**URGENT Field Safety Notice**

Azurion 7 M20 FlexArm system with Maquet Magnus Table  
Unavailable Motorized Table and/or FlexArm Movement Potentially Resulting in Delay or Termination  
of Procedure.

08-DEC-2023

## Attachment 1 C&R 2023-IGT-BST-020 FSN Letter

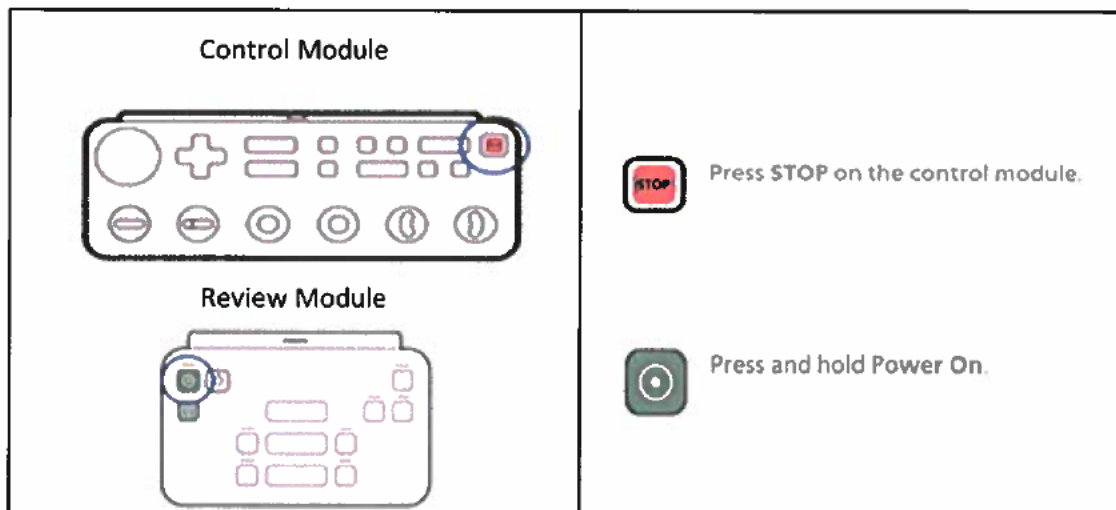
- Until Philips implements the solution in your system. during the procedure:
  - a) Avoid positioning the detector at approximately four (4) cm from the patient.
  - b) If the Connection Issue occurs, perform the following actions in **sequential order**:
    1. move the detector so that it is no longer at approximately four (4) cm from the patient.
    2. if moving the detector doesn't resolve the issue, restart the geometry of the FlexArm as follows:
      - o Press 'STOP' on the **Control Module**
      - o Press and hold the 'Power On' button on the **Review Module**

After this, both Table movement and FlexArm motorized movement will become available again.
